REMARKS

Amendment Dated May 21, 2007
Serial No. 10/812,634

Figure 8

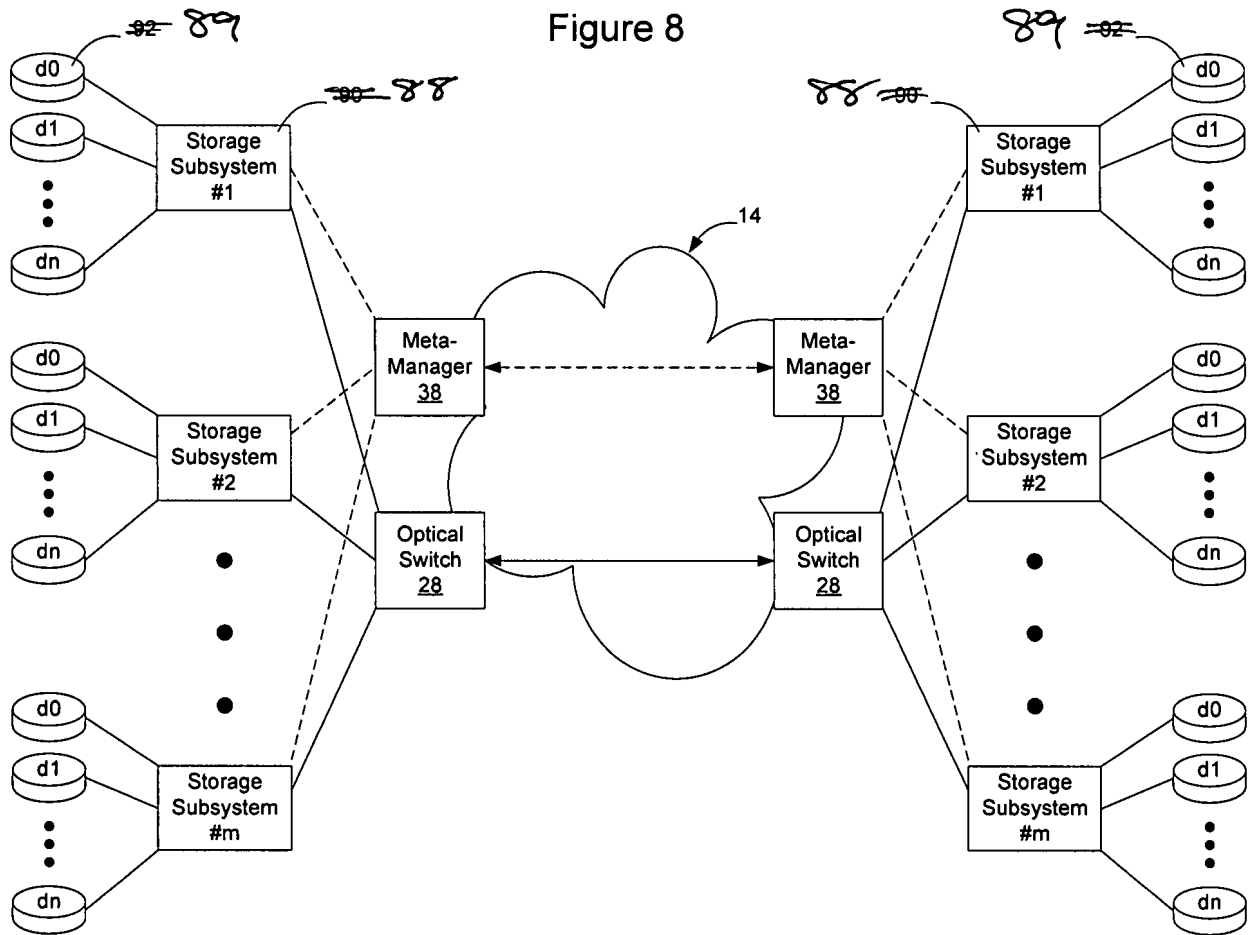
The Examiner objected to the drawings because several reference numerals were used to designate different parts in different drawings. Applicants submit herewith a Drawing Correction Authorization Request in which reference numbers 90 and 92 in Fig. 8 have been changed to 88 and 89, respectively. Conforming amendments have been made to Paragraph [0067]. These amendments do not add new matter to this application. The Examiner is respectfully requested to approve the drawing corrections and the conforming changes to the specification when acting on this Amendment.
